Manual Update Sheet

Document Being Updated: *TMS320C6000 Peripherals Reference Guide*

Literature Number Being Updated: SPRU190D

This Manual Update Sheet (SPRZ122B) describes changes for the *TMS320C6000 Peripherals Reference Guide* (SPRU190D).

Figure 18–7. ATM Controller Slave Transmit Timing

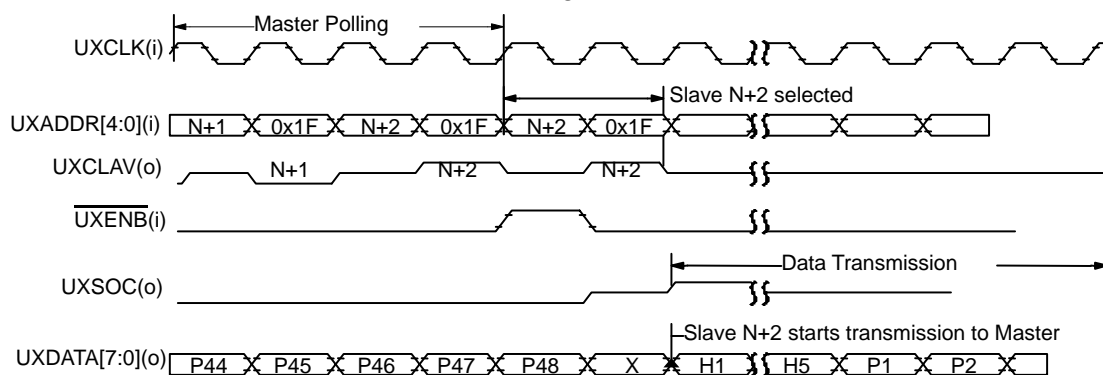
18–11 Change the UXCLK signal in Figure 18–7:

Figure 18–8. ATM Controller Slave Receive Timing

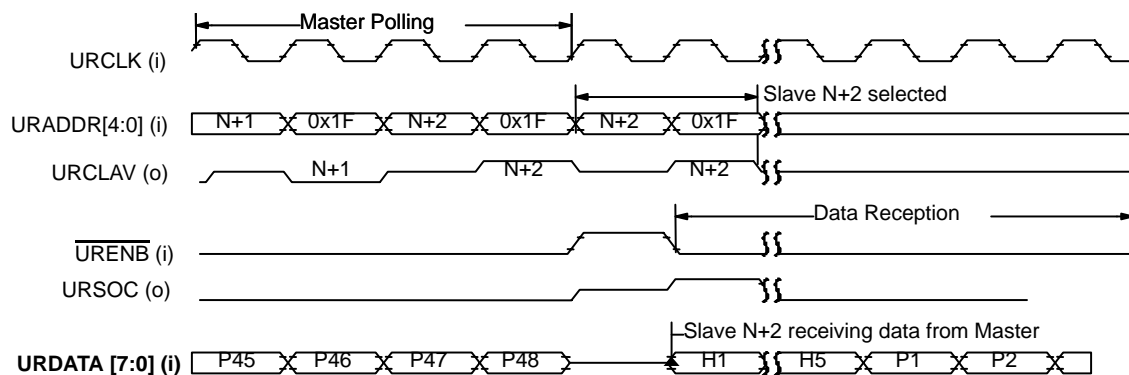
18–14 Change the URDATA signal name in Figure 18–8:
